# CORPORATE REPORT

To: CAO for the Electoral Area Services Committee Date: 2019-05-08

From: David Bennett, Planner II File No: 3060-20-2019-02

**Subject:** Aquadel Crossing Ltd. applied to amend an existing Development Permit (relating to form and character) to permit fencing across common strata property at the development known as Aquadel Crossing, 1885 Columbia Valley Road, Electoral Area "H".

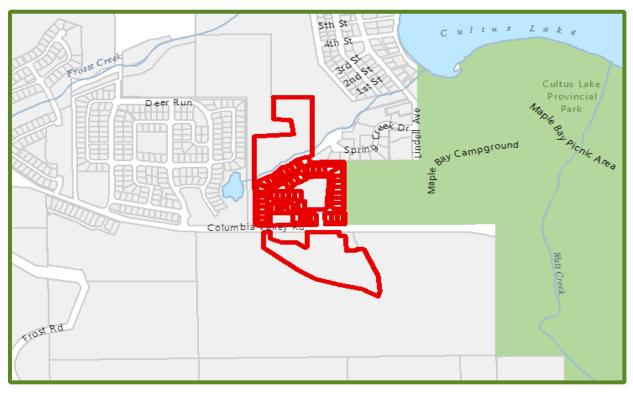
The image above shows the design and material of fencing proposed and how the fences would cut across common strata land within the strata subdivision. The bulk mulched area with plantings is common strata property. The individual's strata lot ends where the grass ends. This common strata property acts as a buffer from neighbouring developments and it is a requirement of the zoning bylaw.

In other areas, the developer is proposing to install dense cedar hedging across the common strata areas as shown above. The bulk mulched area with plantings is common strata property and it forms the buffer between the Aquadel development and adjacent lands. The individual's strata lot ends where the grass ends.

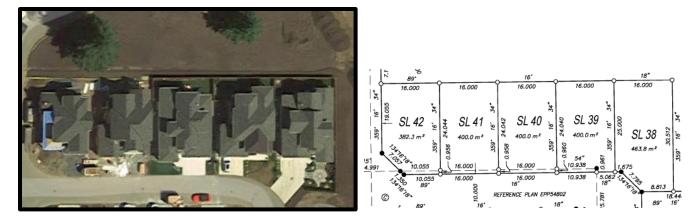
The image above highlights the location of the buffer areas around the perimeter of the development.

As shown in the Google Earth image above, fences installed around the perimeter of strata lots achieves the separation between individual units in the development. There is no concern with strata lot owners fencing along their own lot lines. Lots #38 to 42 are fenced along the boundary of the strata lots and do not extend the rear yards into the adjacent common strata lands. An extract of the subdivision plan is shown above.

The Google Earth image below shows buffer areas are not being maintained equally. In this image, the strata lot #4 increased the lawn area into the required buffer area. Strata lot #7 has installed fences to the north bumping out into a common strata walkway.
